**Warren County – Courthouse Concrete Replacement Project  
Project No. 23-02**

**Contract Addendum No. 2  
October 30, 2023**

Site Overview - Court House  
104 W Booneslick Rd, Warrenton, MO 63383  
Rev 1 Add. 2 - 10/30/2023

SK-02

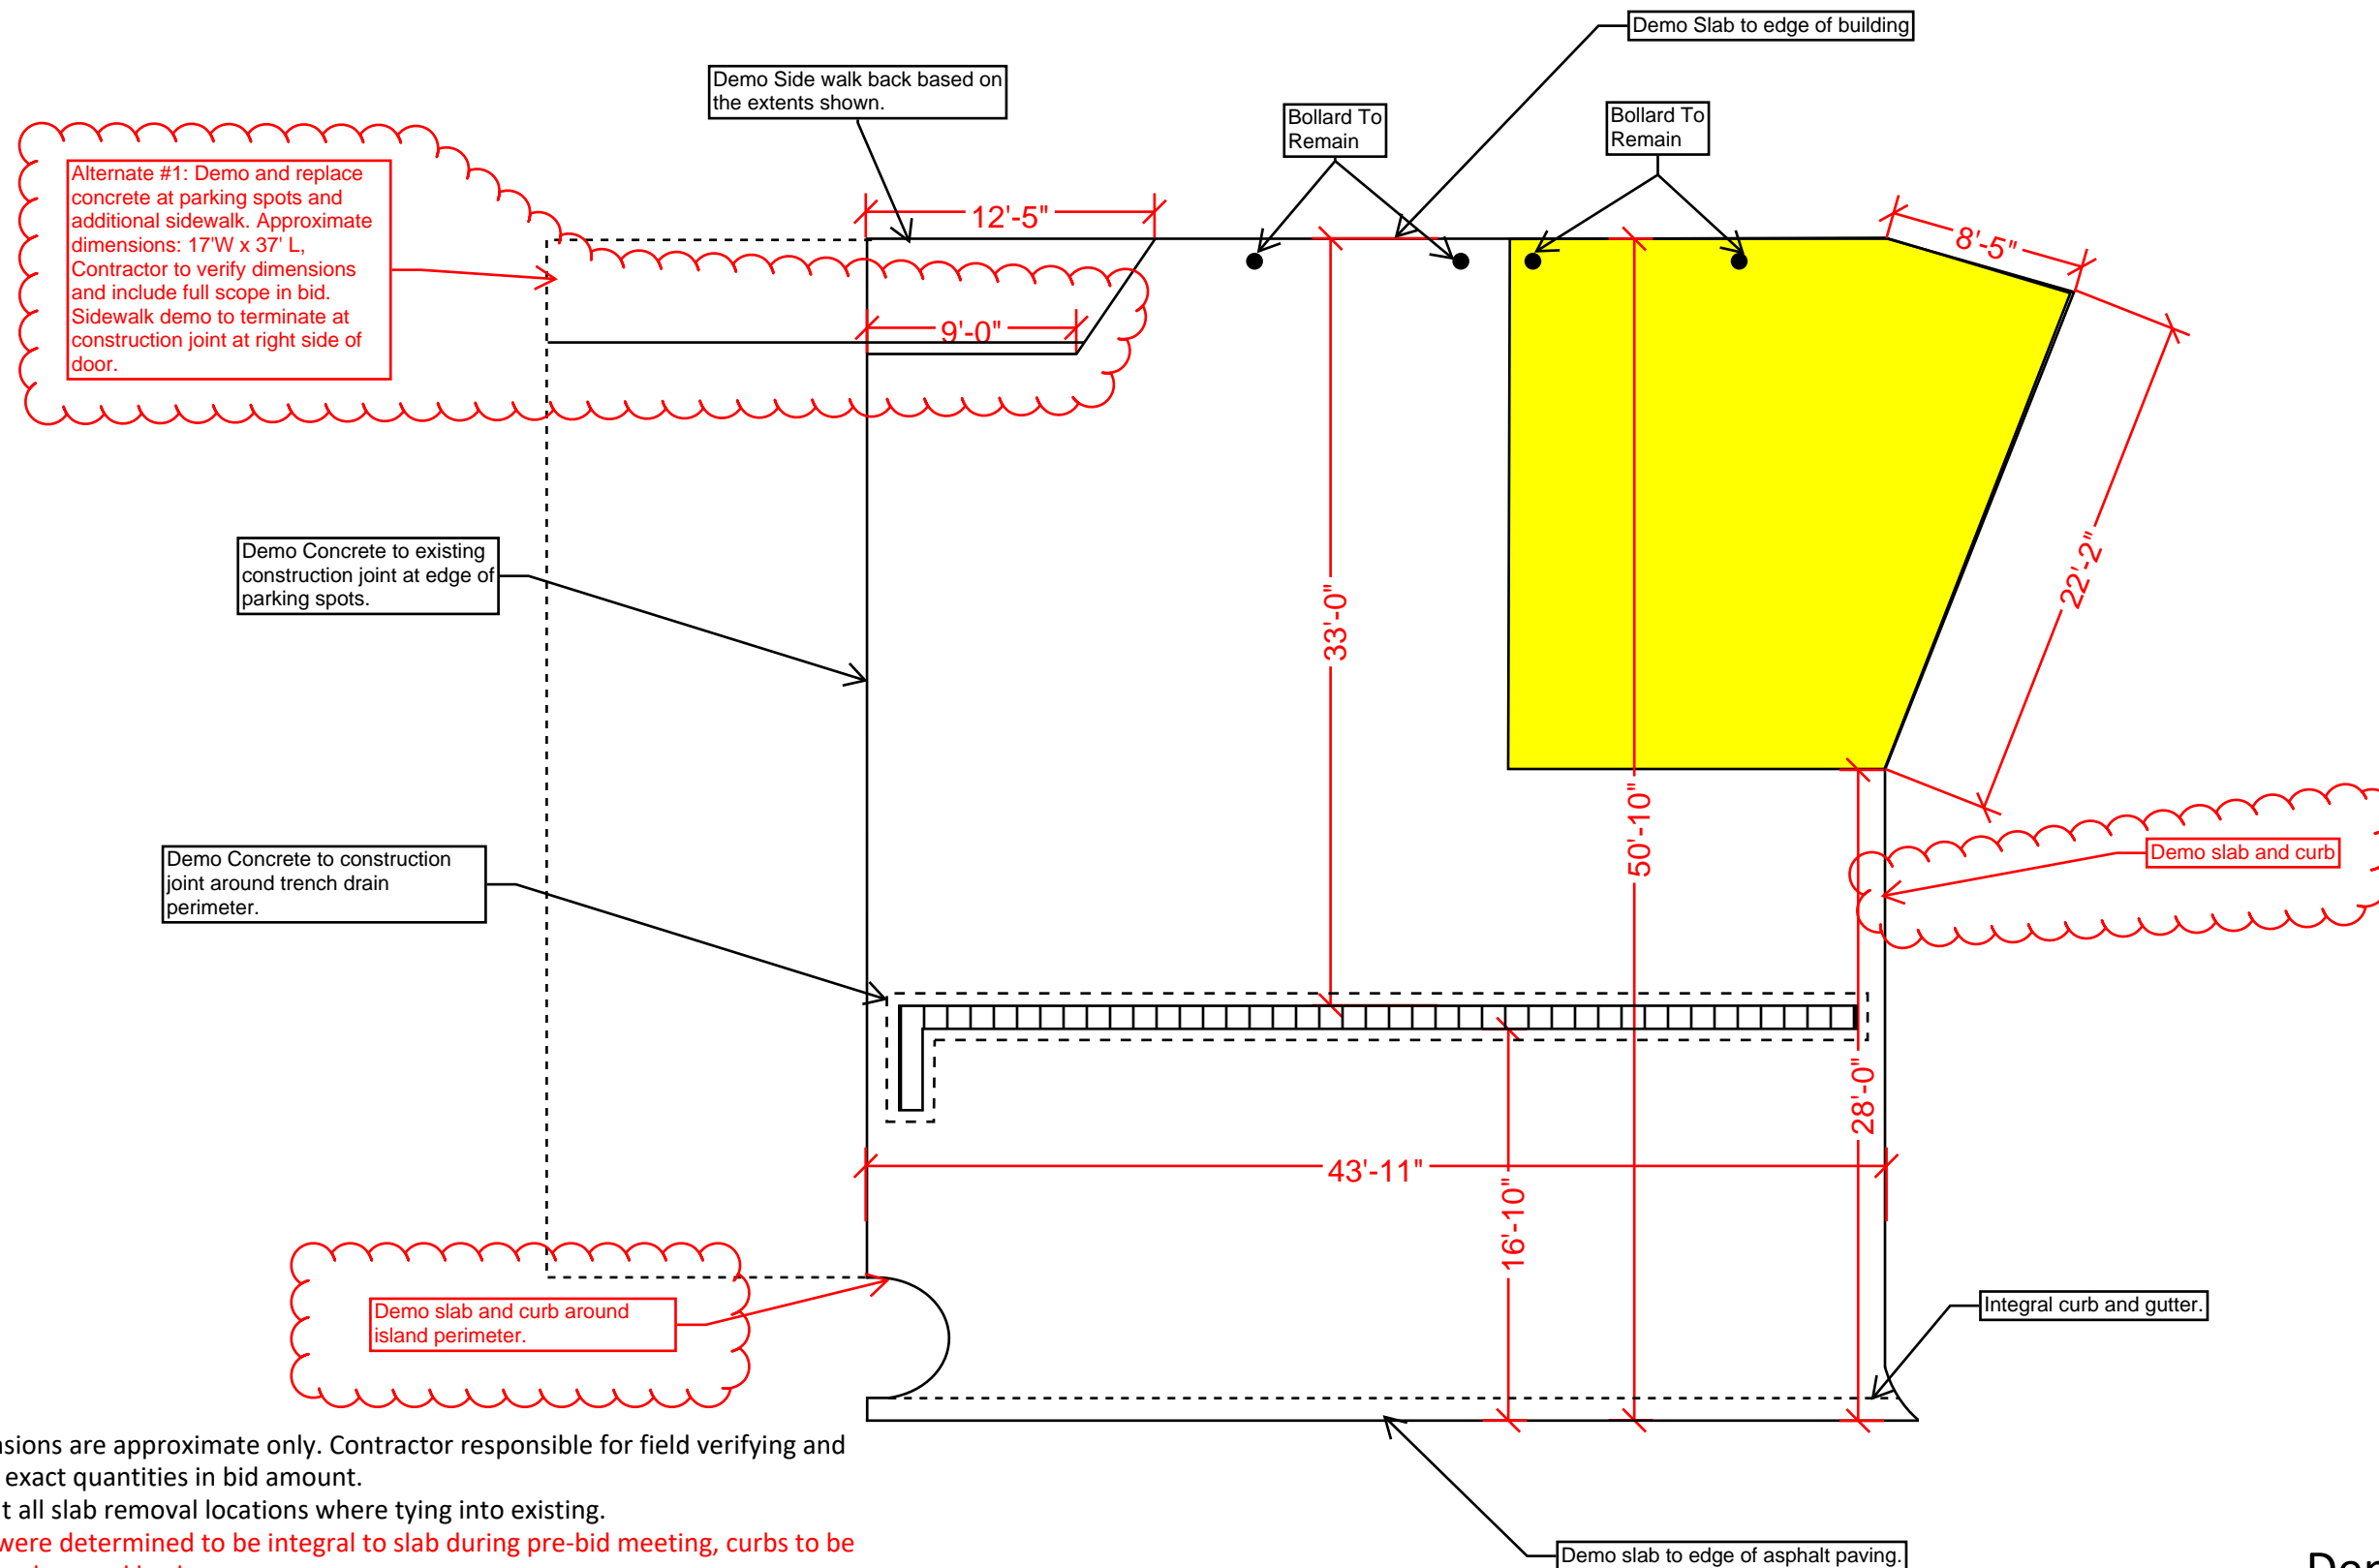
1. Dimensions are approximate only. Contractor responsible for field verifying and including exact quantities in bid amount.
2. Saw cut all slab removal locations where tying into existing.
3. Curbs were determined to be integral to slab during pre-bid meeting, curbs to be demoed and poured back.

**SK-03**

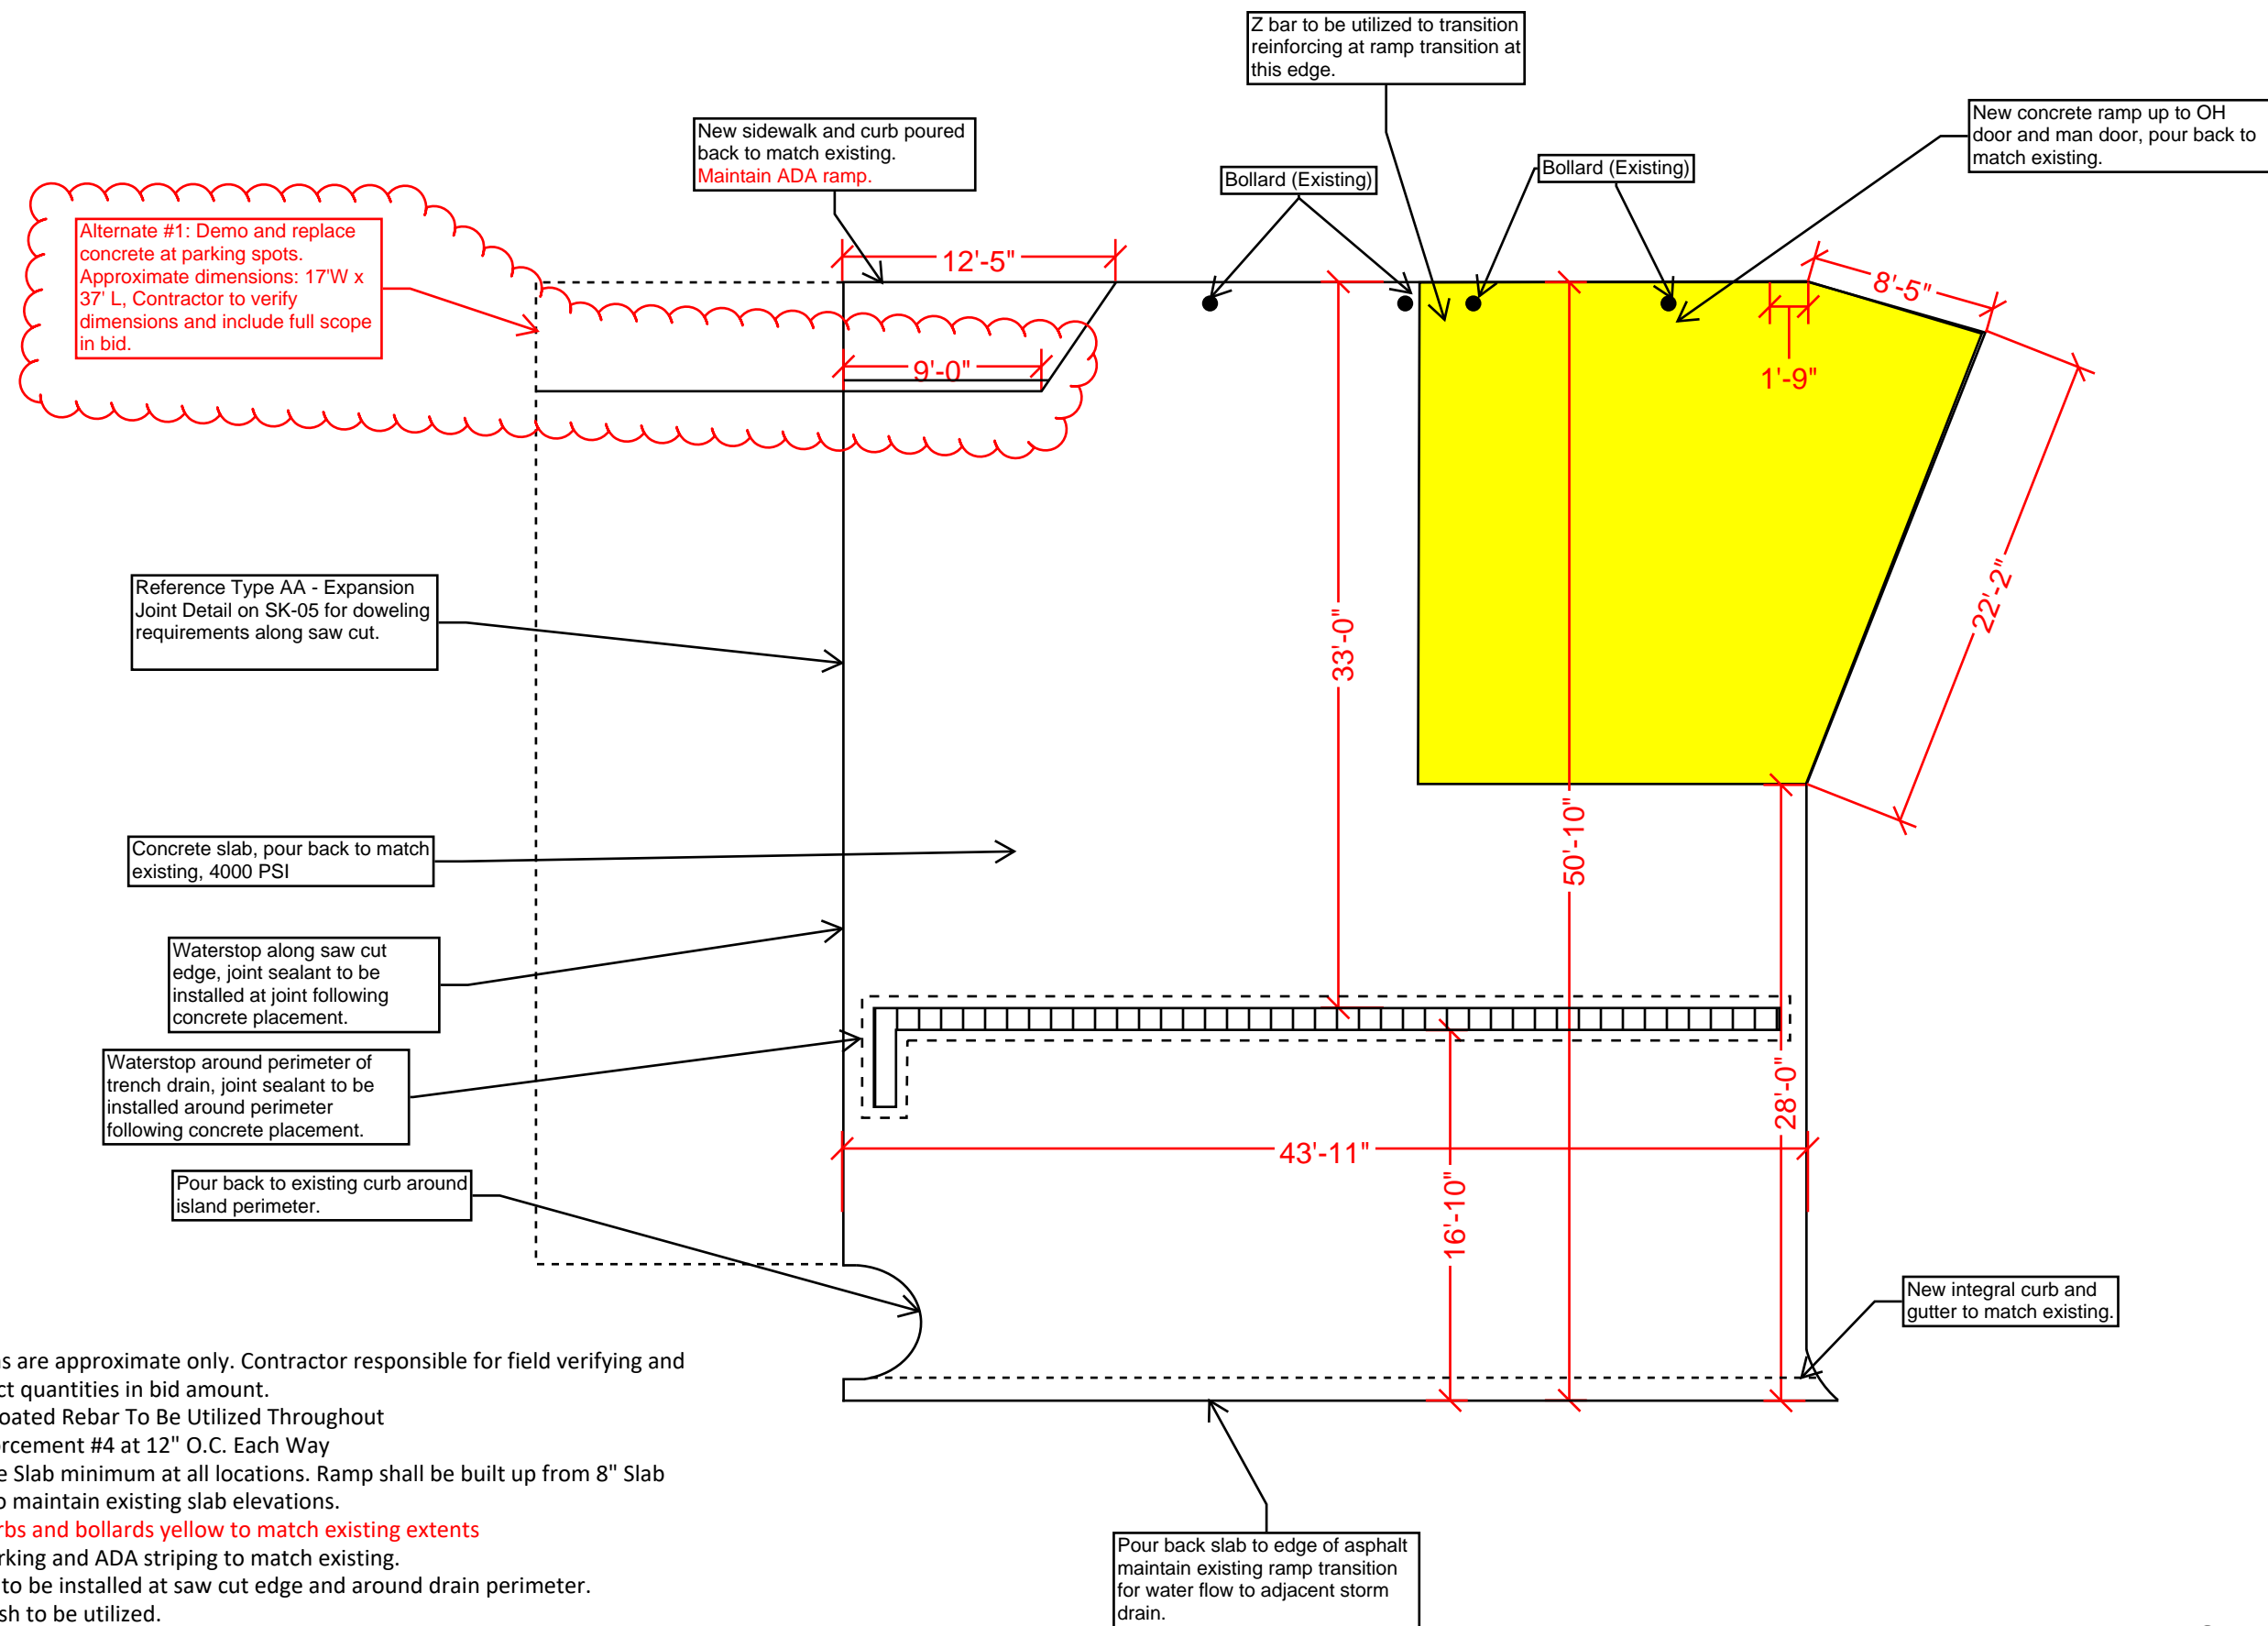
12. Curbs were confirmed to be integral to slab during pre-bid meeting. Curbs shall be removed and replaced during concrete placement.
13. Bollards to remain, if bollards cannot be maintained during demolition, contractor responsible for replacing and repaint.
